Figure 2.12m
Infrastructure Design Review
- Turbine 13

Tangy IV Wind Farm
S36C EIA Report 2026
Proposed Varied Development

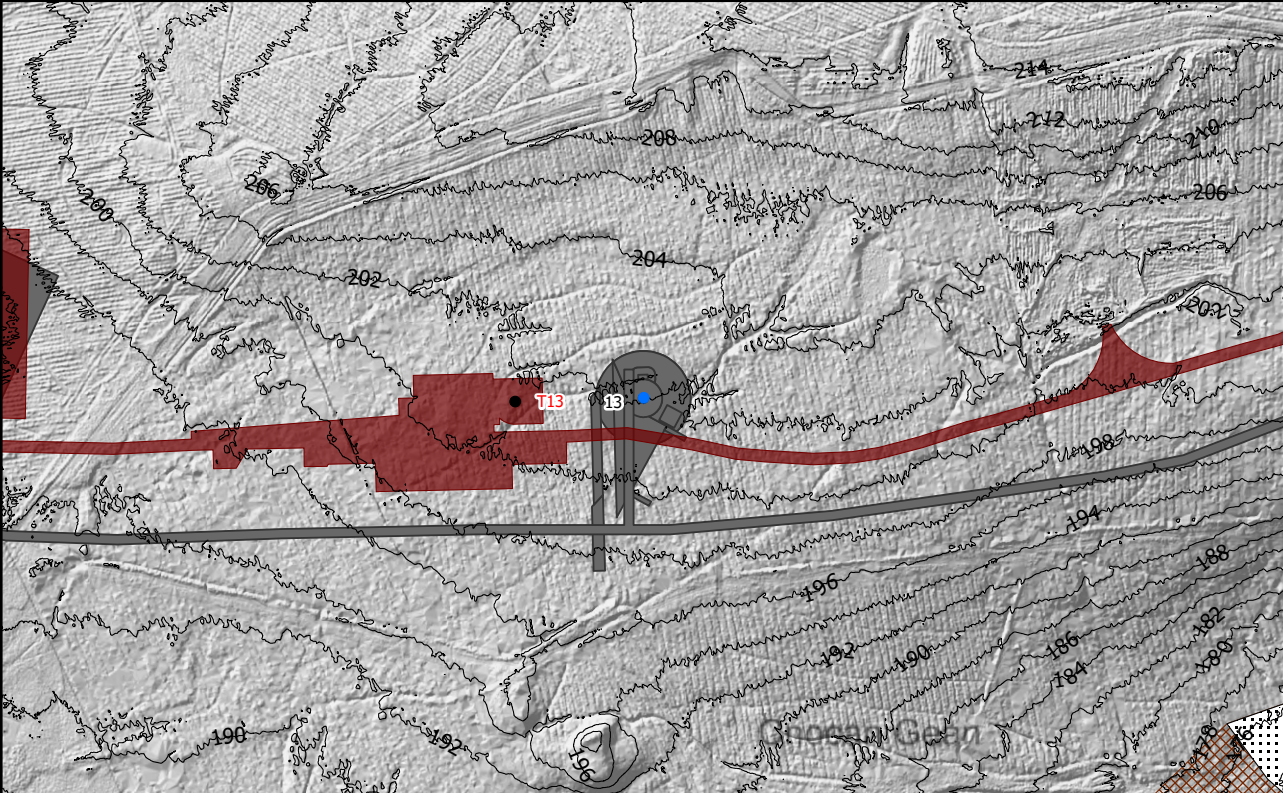
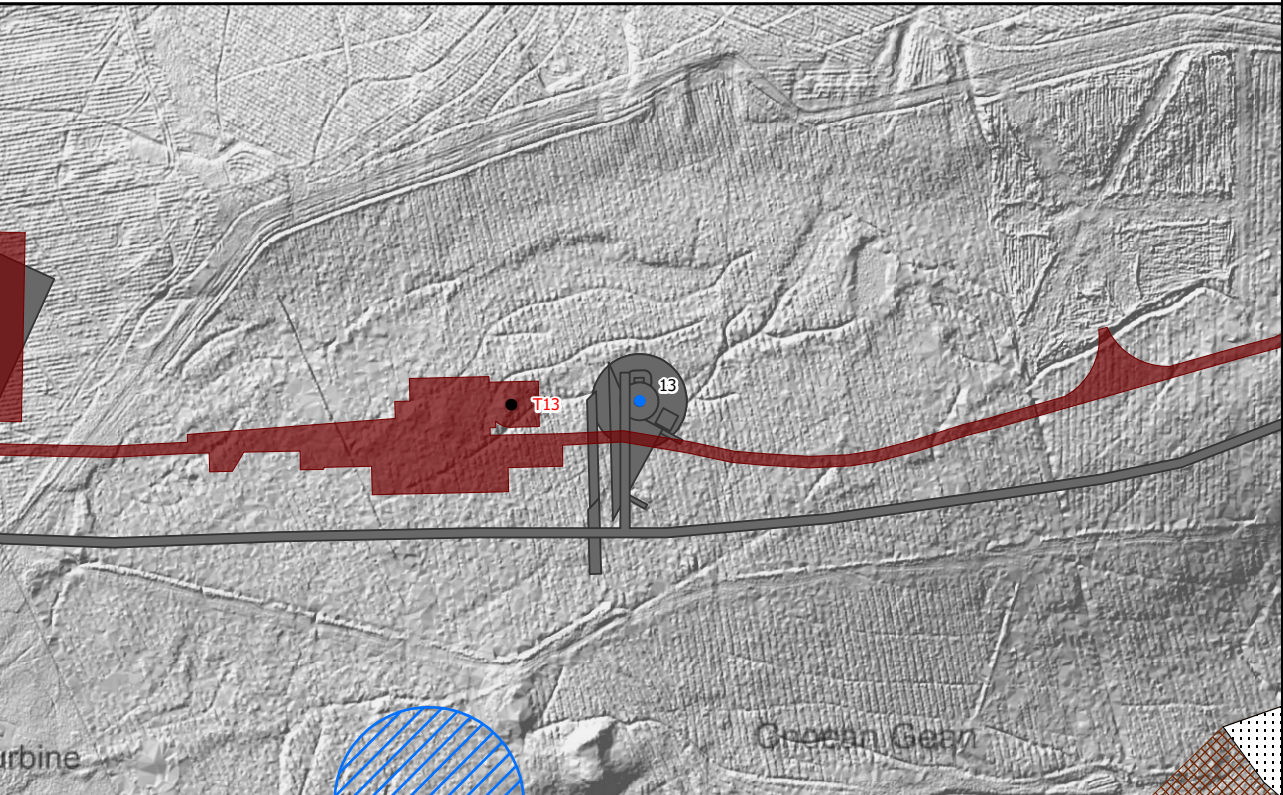
T13: Reason for Moving: This turbine location has been moved to a compromised positions as a result of surrounding turbines. It is believed this is the best location for the turbine, however it is known that it will be impacted by surrounding turbines.

Engineering: The hardstanding for the proposed layout is larger than the current consented layout. Due to this it is not possible for it to meet the track as shown in the consent. The hardstand has been rotated 90 degrees and the track as been realigned as required.
The plan for turbine deliveries is to drive directly onto the hardstand and offload components. The unloaded vehicles will then use the turning head between T12 and T13 to turn and exit the site.

Geology Impacts: The infrastructure has been positioned to have a similar impact to the peat to that of the consented layout. The newly proposed turning head has been positioned so that is sits in an area of shallow peat.

Ecology Impacts: The turbine and infrastructure is located in an area of commercial coniferous forest that will be clear felled as part of the project scope.

Hydrology Impacts: There are no water buffers within the area adjacent to the turbine location.
